**AGENDA REPORT
PLANNING AND ZONING COMMISSION MEETING
APRIL 18, 2013**

A request by C. Stephen Heying (surveyor), on behalf of Bear Creek Properties, LLC (owner), for a three-lot replat to be known as "Landmark Subdivision, Plat 2," sidewalk variance, and easement vacation and dedication. The 5.46-acre site is located north of Country Club Drive and south of McAlester Street. (Case #13-52)

Case 13-52: Landmark Subdivision, Plat 2 Replat and easement vacation/dedication

LANDMARK SUBDIVISION - PLAT 2

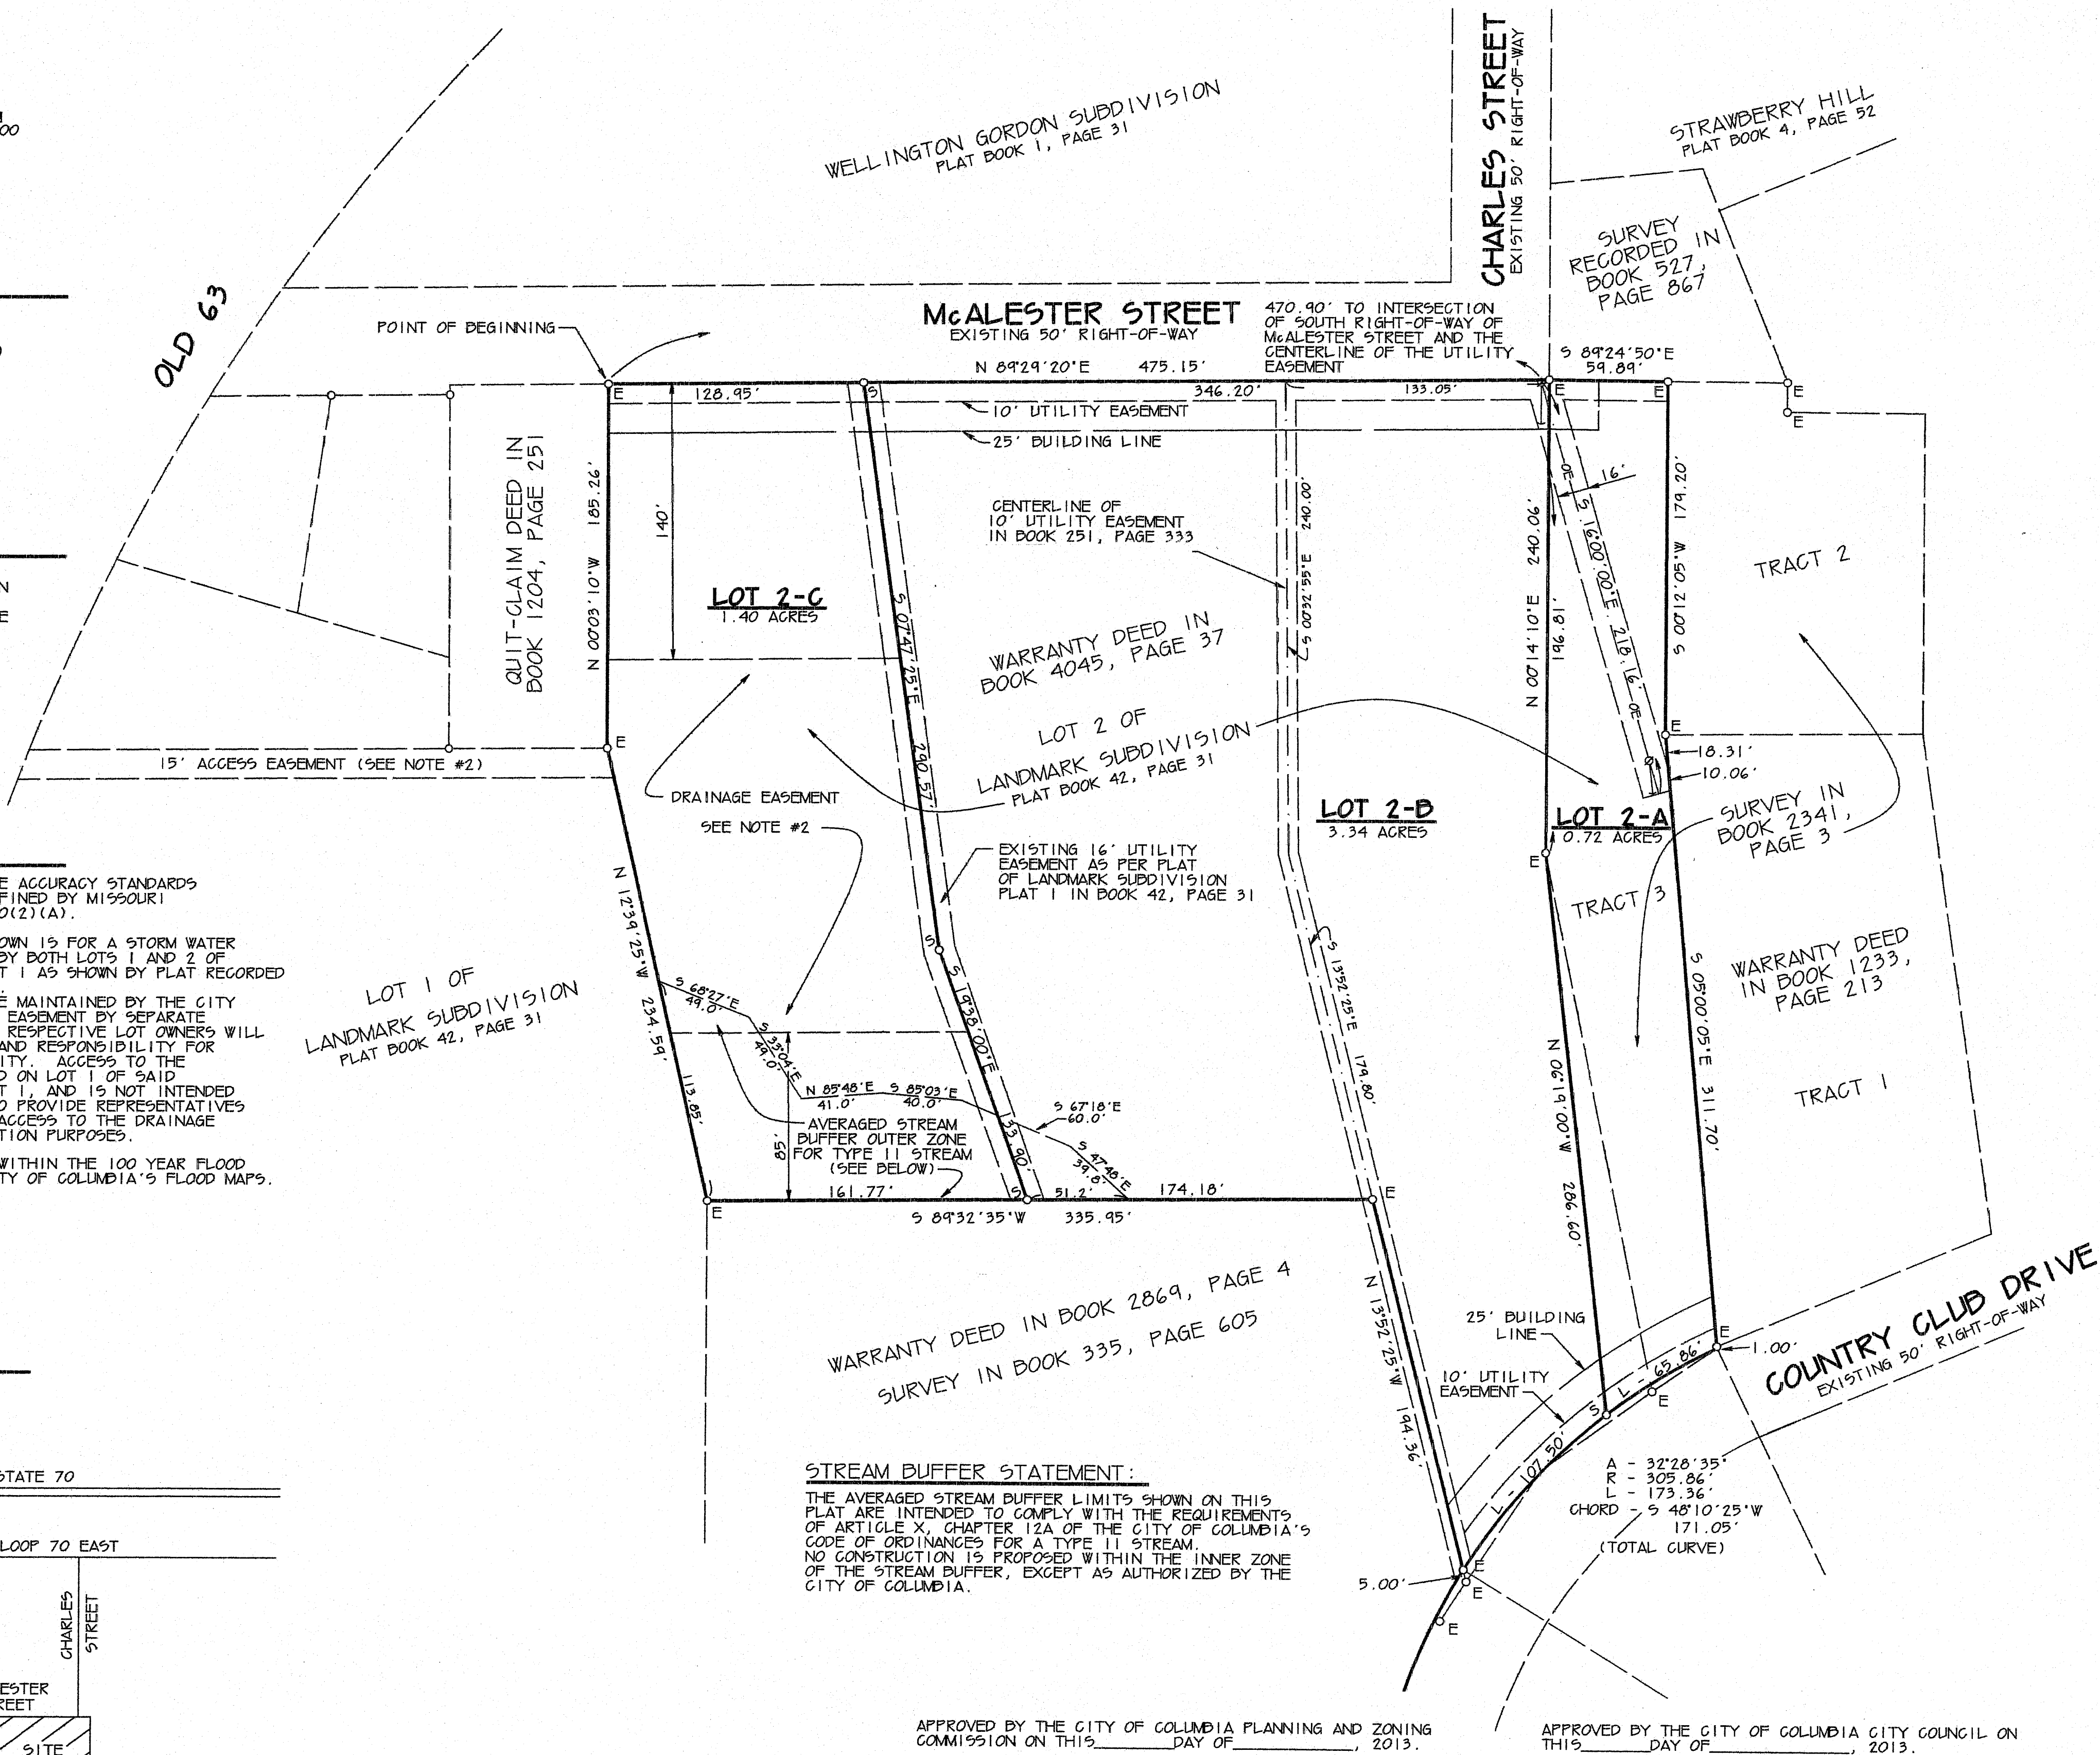
The easement vacation removes a utility easement that cuts north-south through the middle of lot 2-B. A new easement would be added at the northeast corner of lot 2-B to serve lot 2-A. The vacation and dedication have been reviewed and approved by utility providers. The easement vacation was given first reading at Council on Monday, May 6.

The sidewalk variance request to Section 25-48.1 of the Subdivision Regulations is for the portion of the site fronting on Country Club Drive. The nearest sidewalk on this stretch of road is in front of Landmark Hospital, to the west. There is an intervening residential parcel between it and the subject site on Alfred Street, creating a gap, and there is no sidewalk along Country Club Drive. The applicant commits to building the sidewalk along McAlester Street on the north side of the site. As the regulations call for sidewalks when a plat is processed, staff cannot recommend approval of the sidewalk variance.

Staff recommends approval of the replat (including the easement dedication).
Staff recommends denial of the sidewalk variance.
